ORIGINATION FORM

Proposed Revisions to a Standard Plans Index (Please provide all information — Incomplete forms will be returned)

Index Number: 509-070

Index Title: Railroad Grade Crossing Traffic Control Devices

INDEX	SHEET
509-070	3 of 4

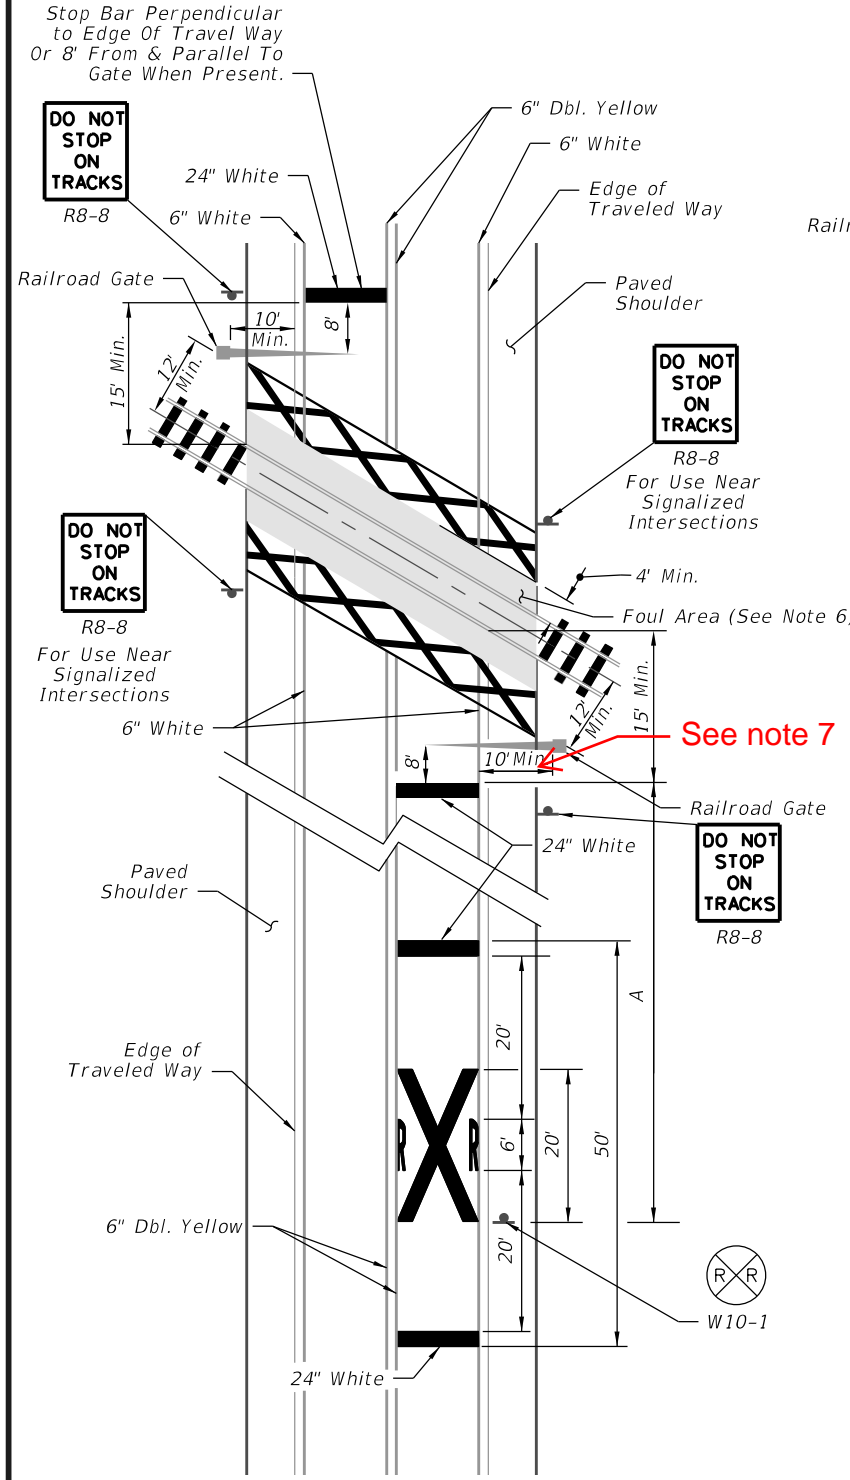
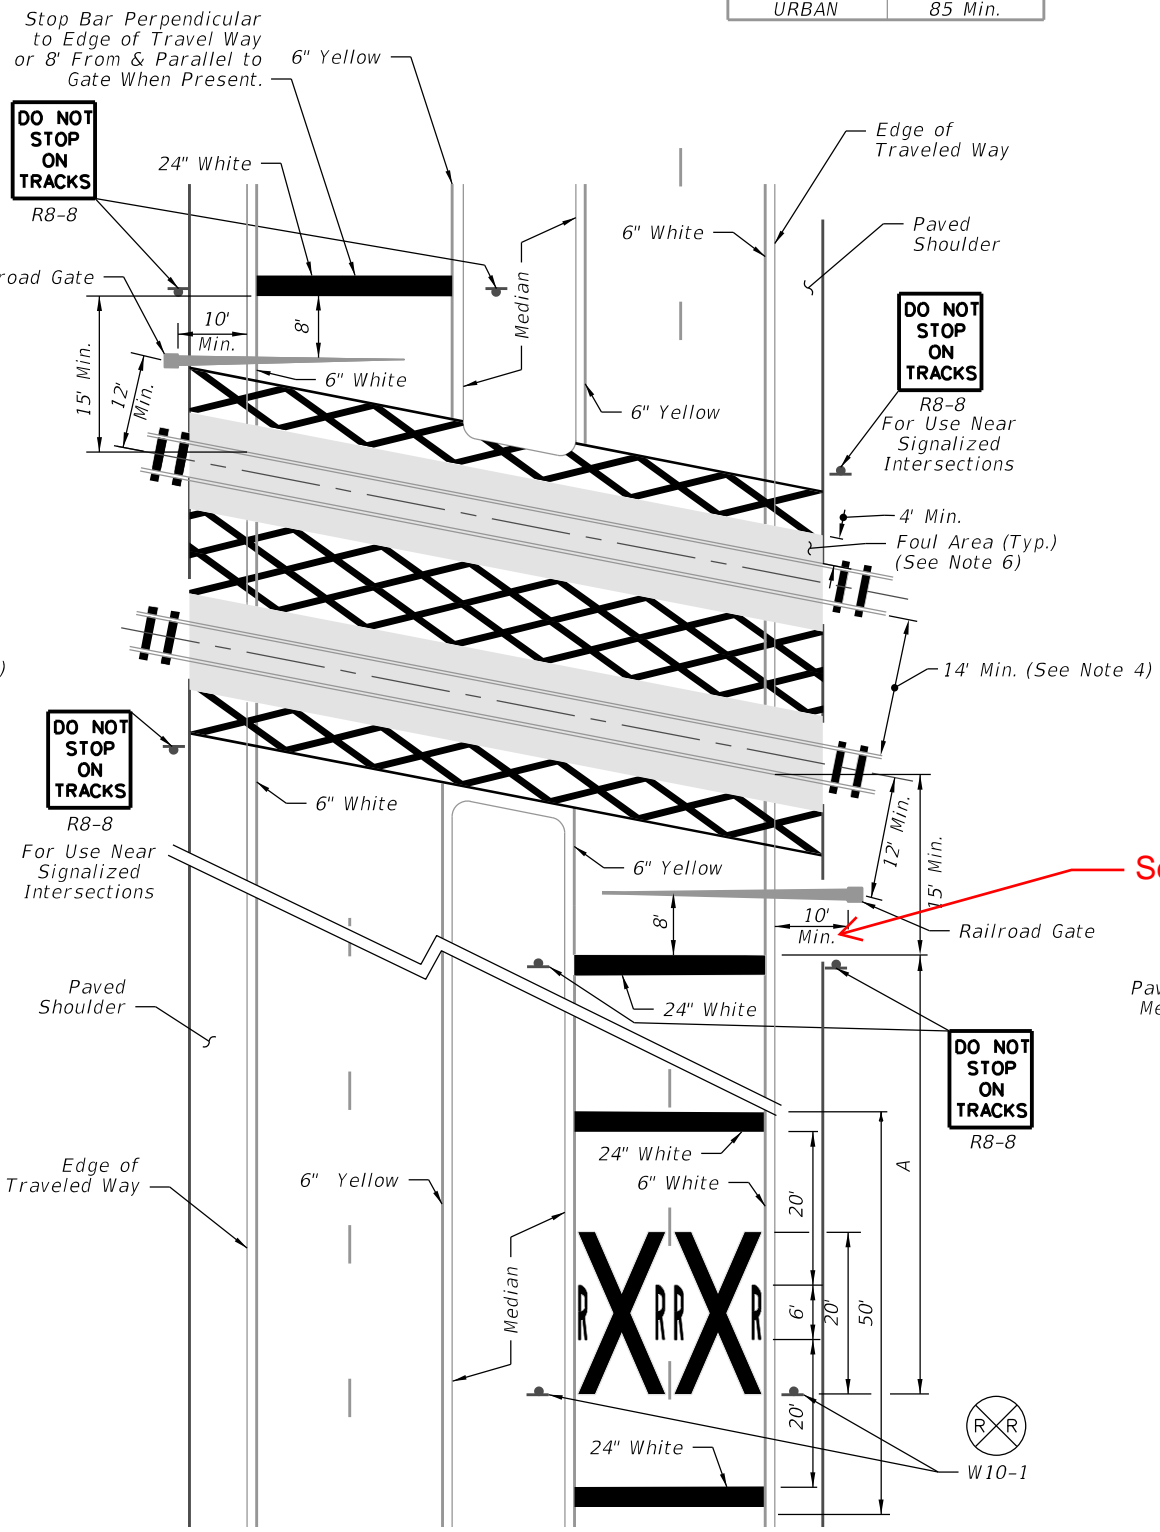
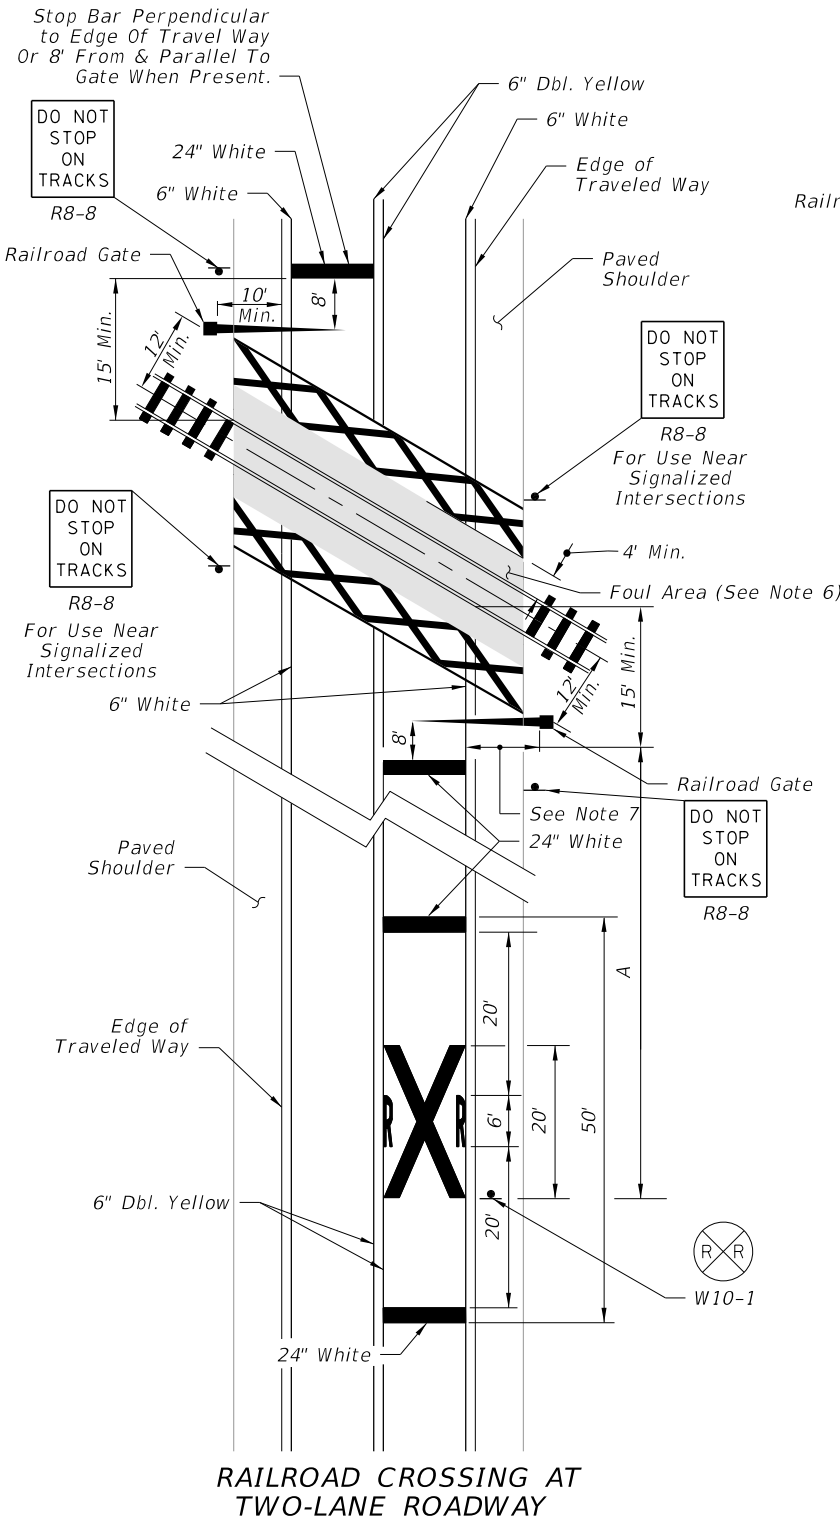
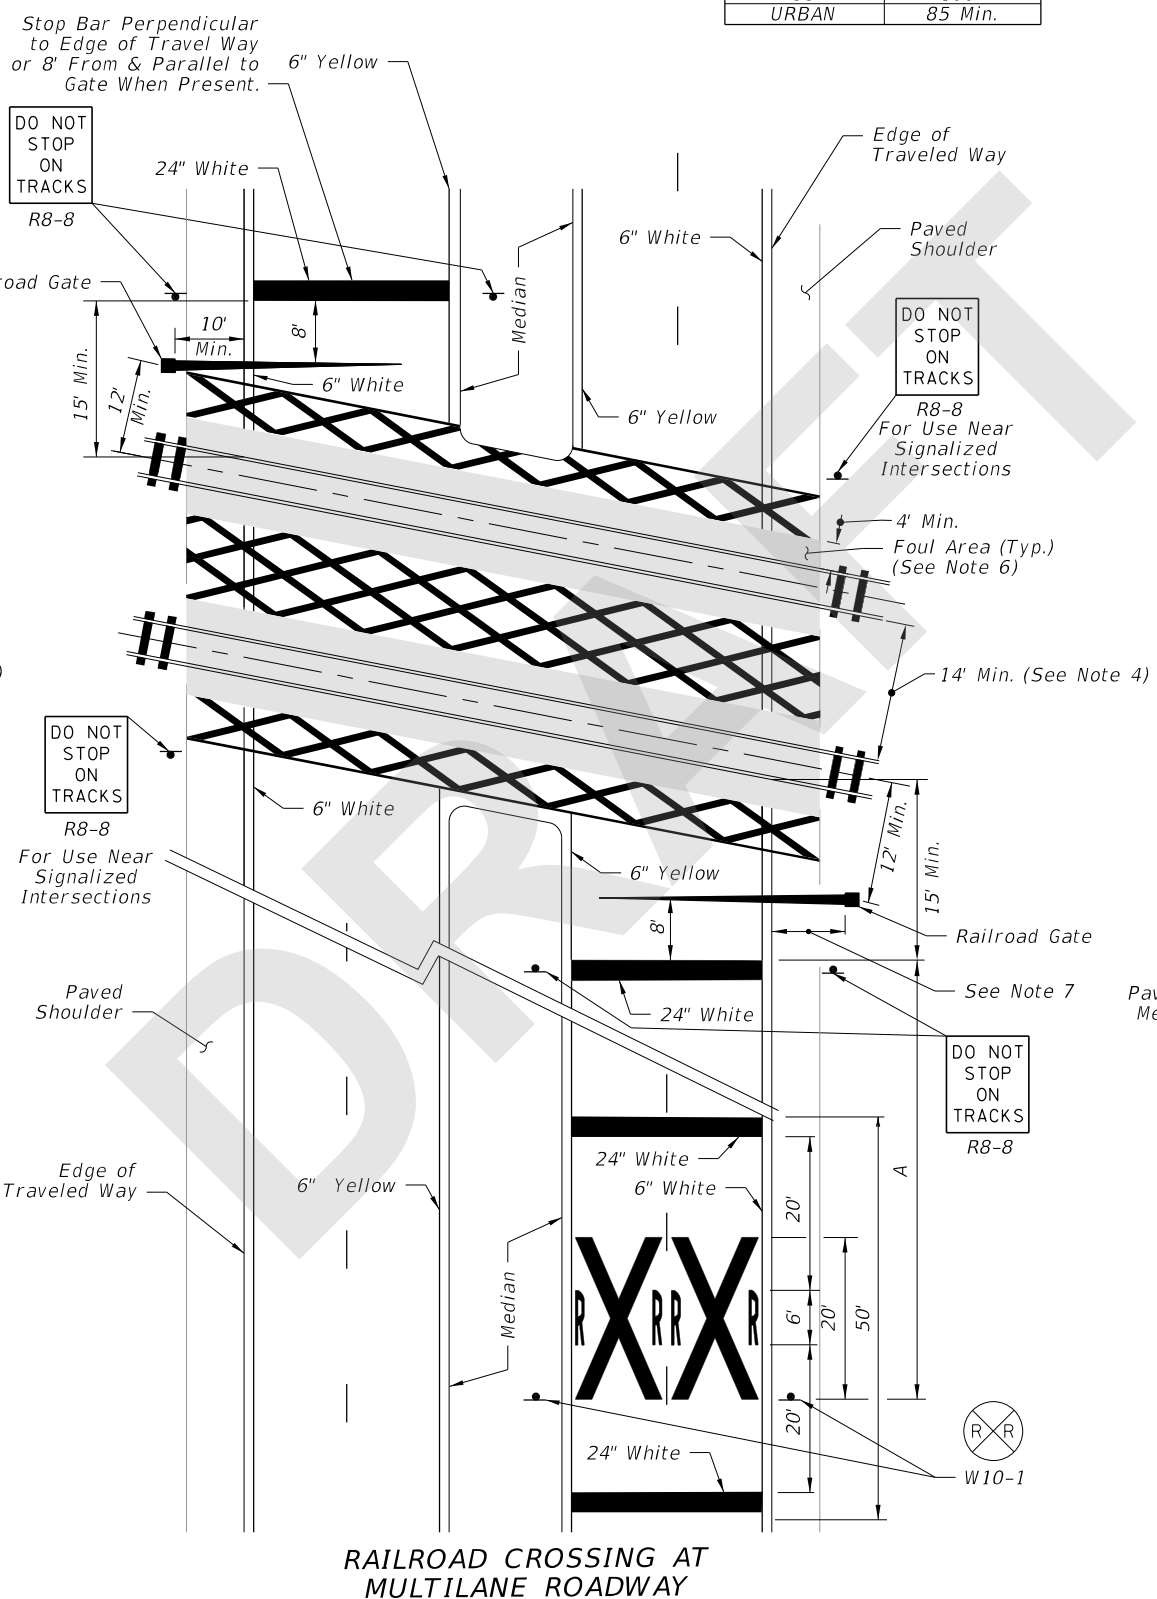
Removed railroad gate dimension from Sheet 3 and add a note that references Sheet 1 and 2.

Change was requested by D2 rail office. Sheet 3 has a minimum distance of 10' labeled to the Railroad Gate. This label should be removed from sheet 3 of 4. This distance is different for flush shoulders versus curb roadways. These distances are clearly detailed on sheets 1 of 4 and 2 of 4 for the various traffic control devices.

1. Place an additional W10-1 sign where intersections occur between the R/R pavement message and the tracks.
2. Place FTP-61-06 or FTP-62-06 sign 100' in advance of crossing for urban conditions and 300' in advance of crossing for rural conditions. See Index 700-102 for sign details.
3. Install Railroad Dynamic Envelope Pavement Markings only when called for in the Plans.
4. Do not install pavement markings when the distance between tracks is less than 14'.
5. The transverse dimension for the RDE "X" may be reduced to the lane width for two-lane roadways without shoulders or when shown in the Plans.
6. Do not install pavement markings in the Foul areas.
7. See Sheets 1 and 2 for dimension.
